UNITED STATES PATENT AND TRADEMARK OFFICE

APPLICATION NO.	FILING DATE	FIRST NAMED INVENTOR	ATTORNEY DOCKET NO.	CONFIRMATION NO.
10/522,746	01/26/2006	Bo Stenvall	10400-000139/US	9316

Office Action Summary	Application No. 10/522,746	Applicant(s) STENVALL, BO	
	Examiner BRENT W. HERRING	Art Unit 3633

DETAILED ACTION

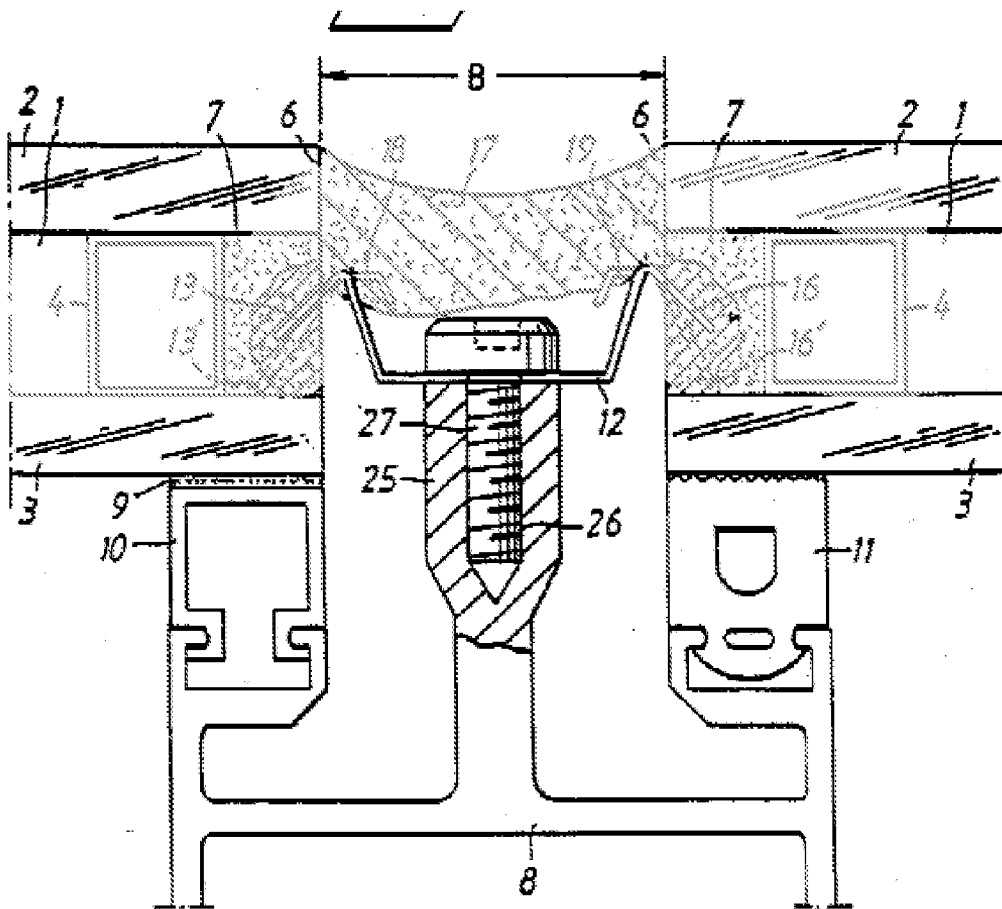
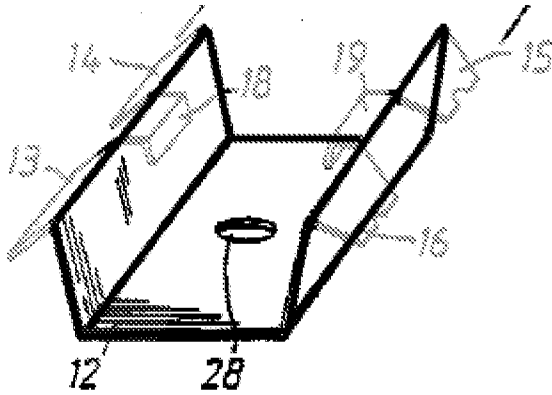
Regarding claim 11:

'831 discloses a device that is *capable of being used in glass wall claddings capable of mounting insulating glass-sheets, each glass sheet having at least two glass slabs which are joined together by a jointing substance, said device comprising:*

- a retainer member (12, 8, see modified Figs. 1, 2 below)

- an anchoring member (13-16, 18, 19, see modified Fig. 2, below)

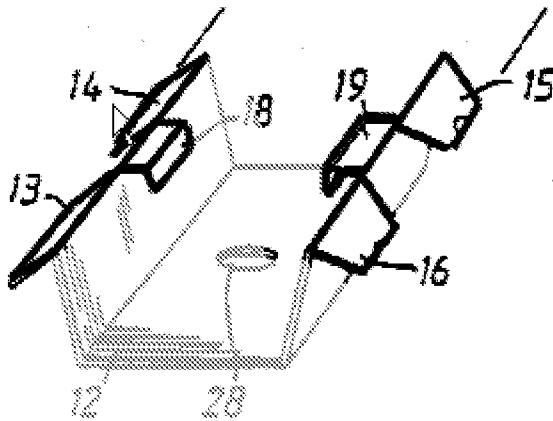
Wherein said retainer member has an articulated connection to said anchoring member (see Figs. 3a, 3b, wherein there is a flexible joint between the portions), such that said anchoring member is rotatable from a first position of rest (Fig. 3a, note that the tool acts to hold the anchoring member at rest) to a second position (see Fig. 3b), in said first position, said device, upon mounting of said insulating-glass sheet, allows the insulating glass sheet to be placed in a desired position, and in said second position, upon mounting of an insulating-glass sheet, said device grips at least one glass slab of said insulating glass sheet, wherein a portion of the anchoring member, upon mounting of a sheet, is arranged to penetrate into said jointing substance of an insulating-glass sheet as the anchoring member of the device is guided from said first position to said second position, in response to the anchoring member being tilted to said second position.

'831 discloses claim 2, wherein said groove is undercut (see modified Figs. 2 above) and wherein said anchoring member is arranged for tilting movement about an axis adjacent and along the opening of said groove (see Fig. 2).

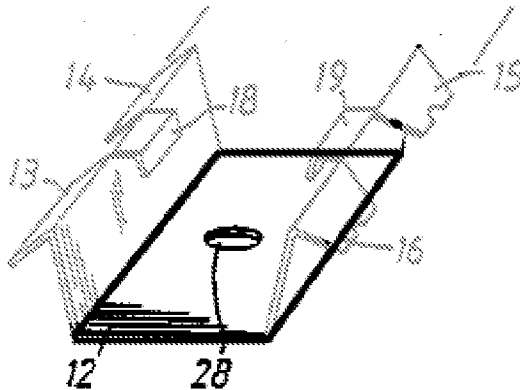
'831 discloses claim 11, wherein said anchoring member is rotatable from a first position of rest to a second position of rest. As explained above, a "position of rest" is one in which motion does not occur. The tongs of '831 provide for a position of rest.

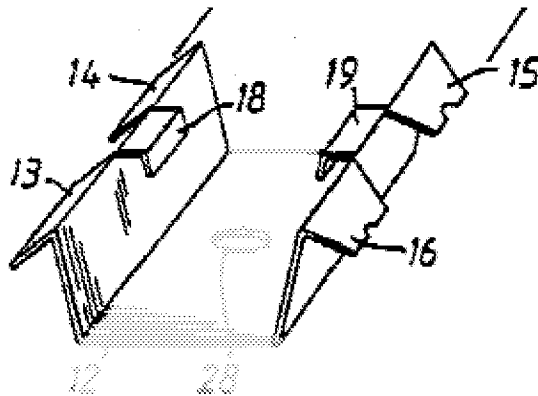
- a retainer member (12, 8, see modified Fig. 2 below)

- an anchoring member (13-16, 18, 19, see modified Fig. 2 below)

Wherein said retainer member has an articulated connection to said anchoring member (see Figs. 3a, 3b, wherein there is a flexible joint between the portions), such that said anchoring member is rotatable from a first position (Fig. 3a) to a second position (see Fig. 3b), in said first position, said device, upon mounting of said insulating-glass sheet, allows the insulating glass sheet to be placed in a desired position, and in said second position, said device grips at least one glass slab of said insulating glass sheet, wherein a portion of the anchoring member, upon mounting of a sheet, is arranged to penetrate into said jointing substance of an insulating-glass sheet as the anchoring member of the device is guided from said first position to said second position, in response to the anchoring member being tilted to said second position.
